**Re: Response to Preliminary Geologic/Seismic Hazard Review and
Supplemental Geologic Investigation
Proposed Senior Housing Facility
4200 Dove Hill Road
San Jose, California
Langan Project No.: 770619902**

This letter presents our response to review comments by the San Jose Department of Public Works (SJDPW) dated 25 September 2015 regarding our Geotechnical Investigation and Geologic Hazard Evaluation report dated 30 June 2015 for the proposed senior Housing Facility project at 4200 Dove Hill Road in San Jose, California. SJDPW had several comments (designated 1 through 13 in their review letter) regarding geologic/seismic hazards evaluation and mitigation at the site; a copy of the review letter is included in Appendix D. The project will consist of two new buildings, designated as Buildings A and B; both buildings are proposed to be four stories above a podium level as shown on Figure 1.

\\nrgen.com\Users\jst\jst\proj\770619902\Cadd - Basis - 770619902\2D - Design\Final\Sheet\1-1'.dwg 2/29/16

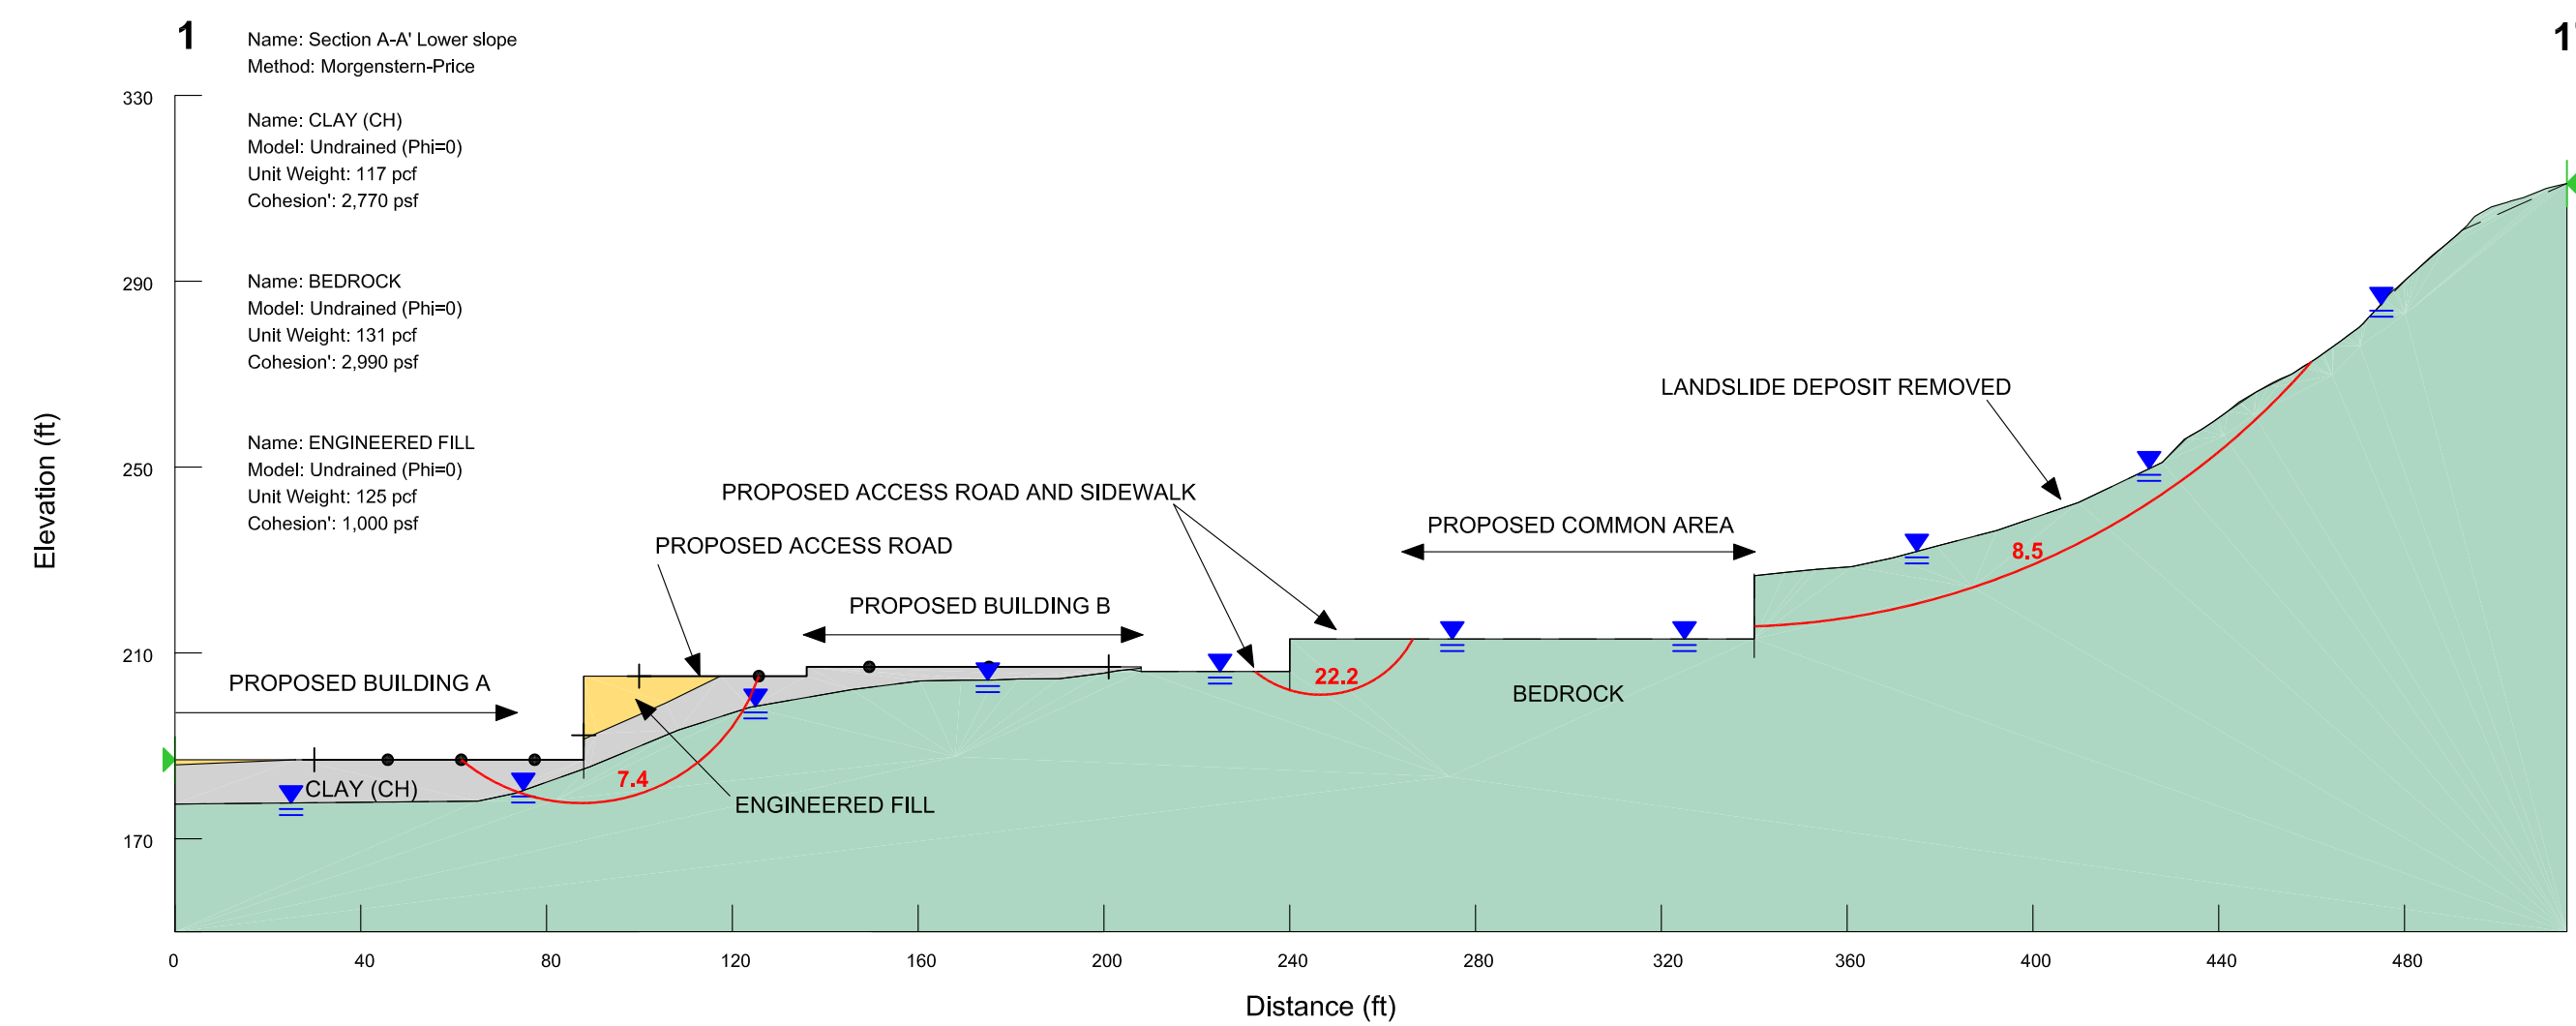
SJDPW stated that large cut and fill slopes are not shown on the grading plan and that the proposed grades do not appear to have been incorporated into our slope stability analysis models. They requested that proposed cut/fill slopes and finished grades be shown on the grading plan and incorporated into the slope stability analyses and analyzed for static and seismic slope stability.

Current plans are to grade the proposed building pads and outlying access roads and sidewalks. Grading will consist of cut and fill to level out areas for the proposed buildings. If the development is graded as proposed including removal and regrading of the existing landslide south of building B, the results of our analyses indicate an adequate safety factor. The results

of our slope stability analyses and seismic slope displacements, which include the proposed grading, are summarized in Table 3. The location of the critical slope failure surfaces for each of the profiles evaluated are provided on Figure 5.

The grading plans have been updated and are presented on the figures presented in Appendix C. In our initial evaluation we modeled the slopes under the existing and post-grading conditions both statically and seismically; however, since the engineering properties and grades have changed, we reassessed the slope analysis as suggested in previous comments. The location of the critical slope failure surfaces for each of the profiles evaluated are provided on Figure 5.

Project No. 770619901	Drawing No. C4.01
Date 2/26/2016	
Scale 1" = 30'	
Drawn By DKS	Checked By DJH
Submission Date X	Sheet 5 of 12

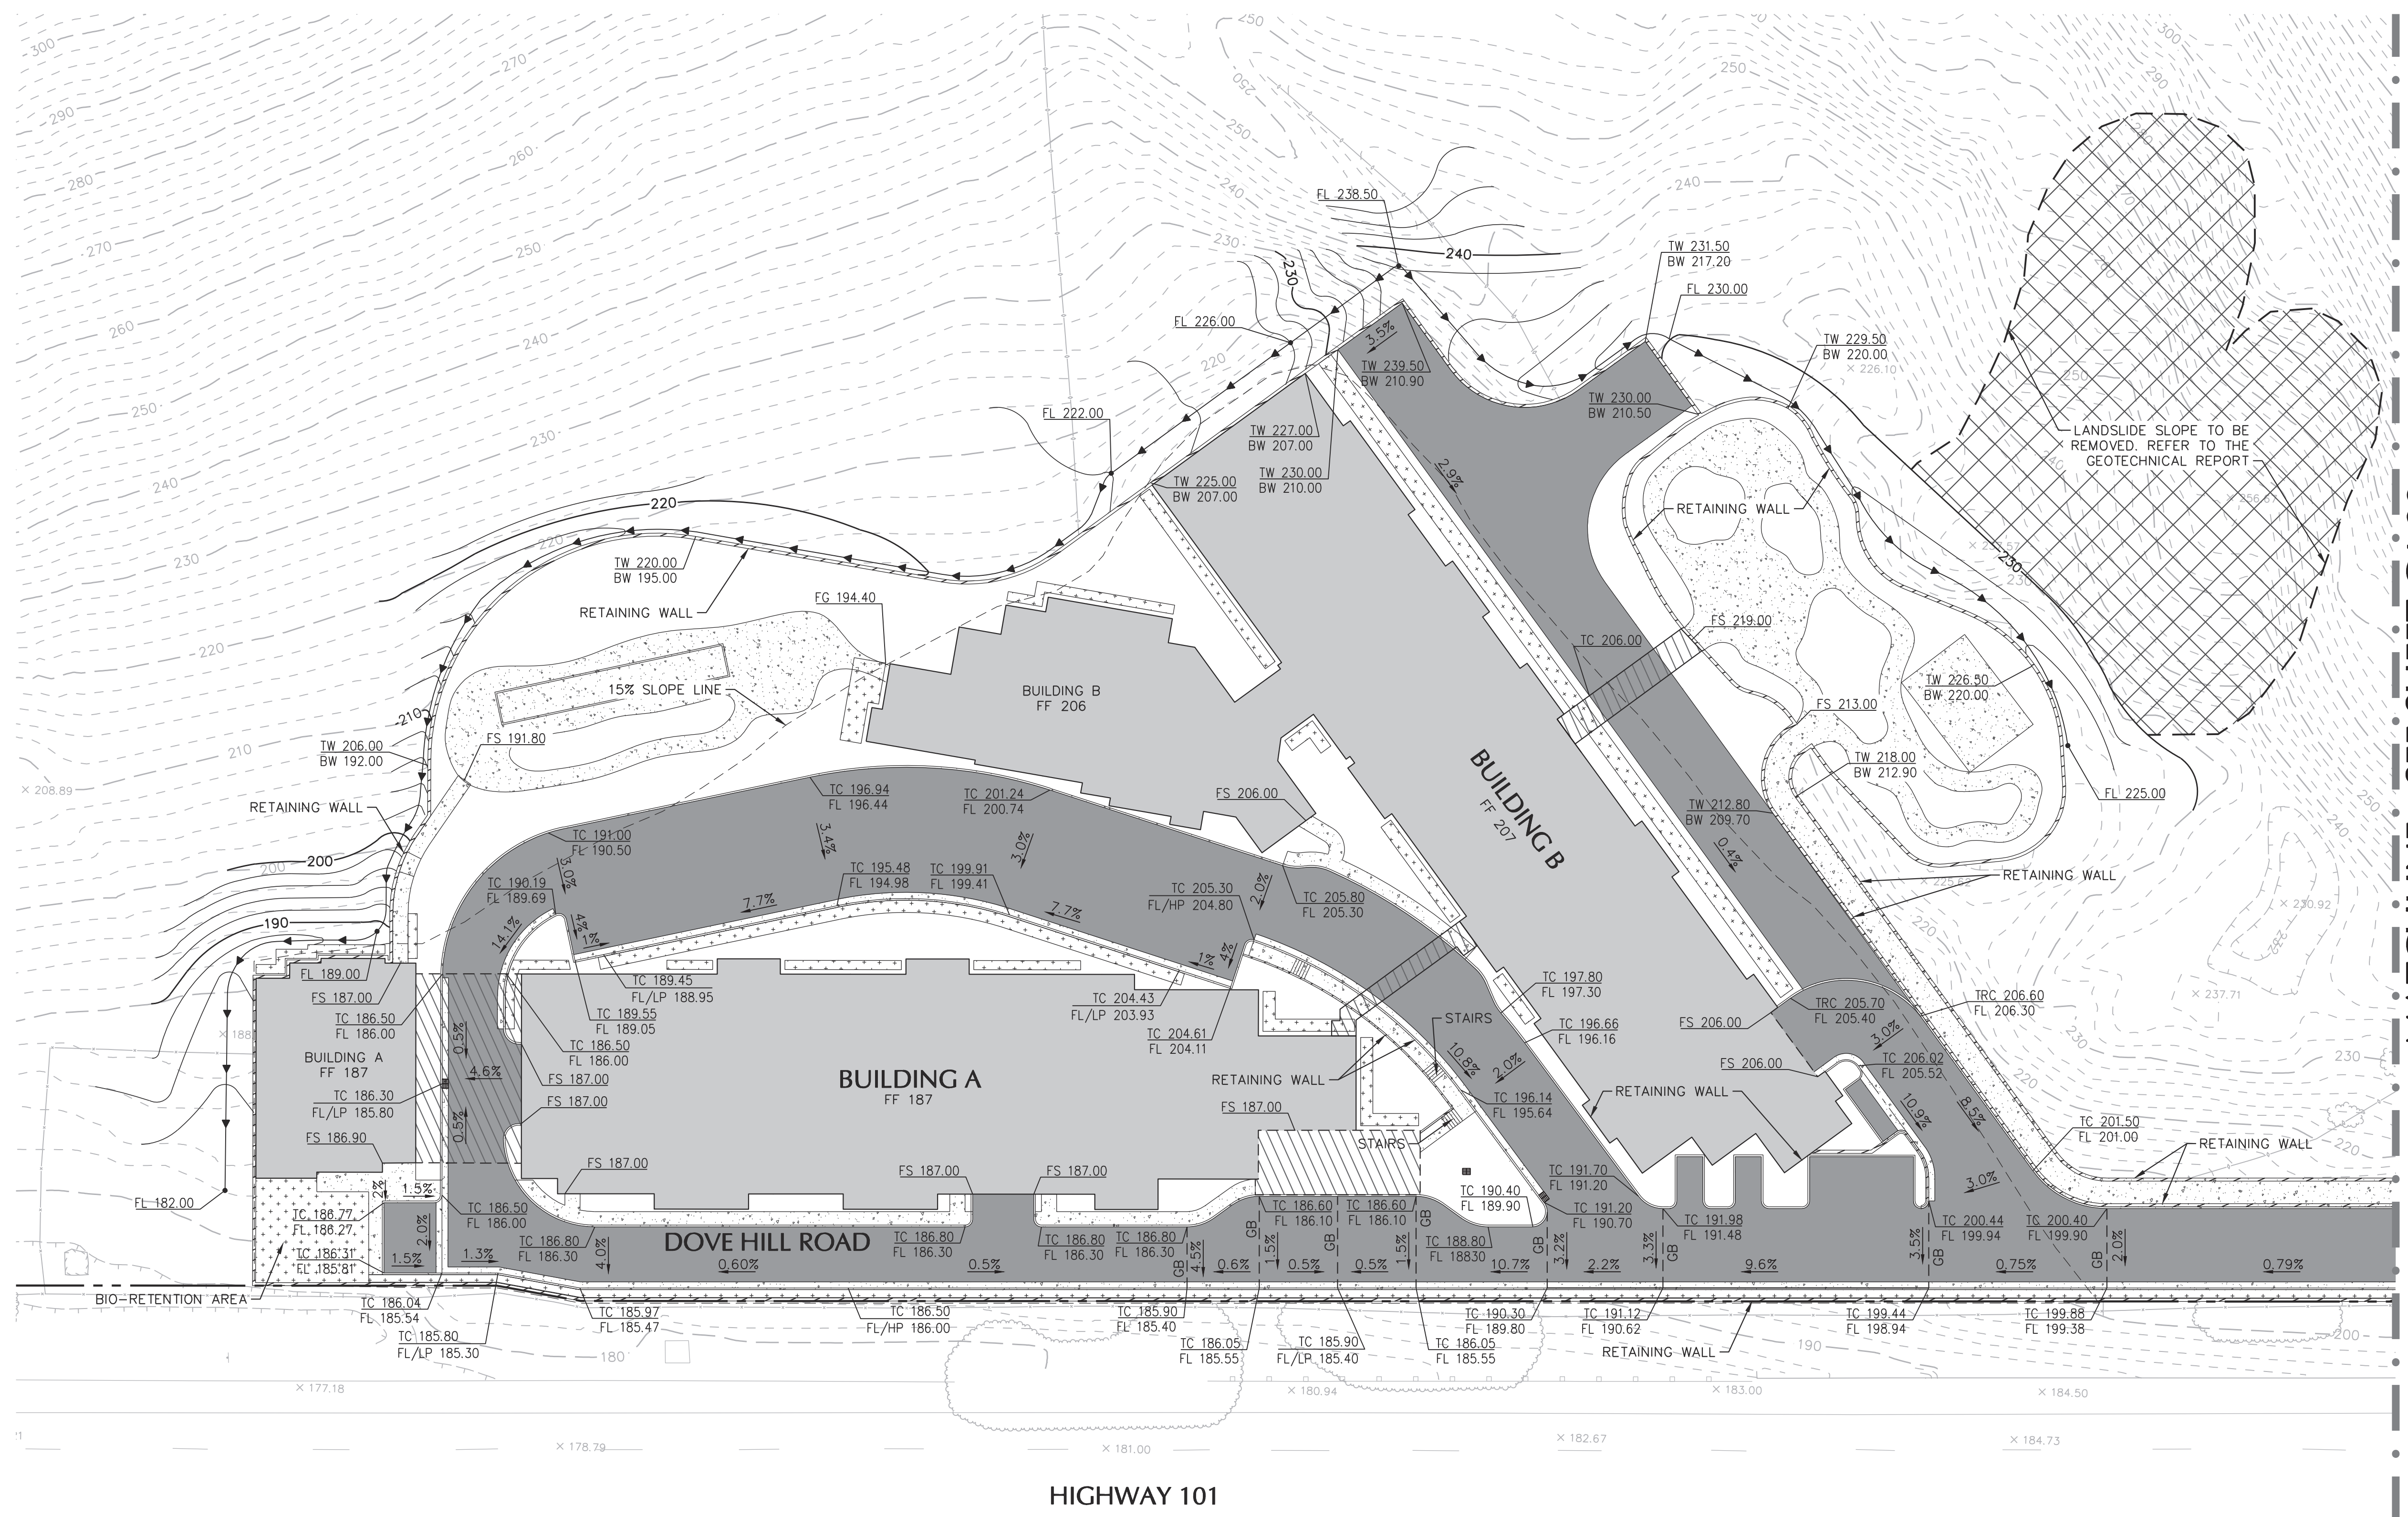
SJDPW stated that the northeastern portions of Buildings A and B are immediately adjacent to high existing slopes and the buildings need to be setback at least 15 feet from the toes of these slopes to be in conformance with the City's Grading Code, Section 17.04.410. The purpose of the setback is to allow for positive surface drainage around the perimeter of the buildings and to establish a buffer zone to mitigate potential impacts from surface water runoff, erosion, and slope instability.

The grading plans have been updated and are presented on the figures presented in Appendix C. See response to comment 1 for additional details concerning the supplemental subsurface exploration.

The grading plans have been modified with a 15 foot setback zone and are shown on the figures presented in Appendix C.
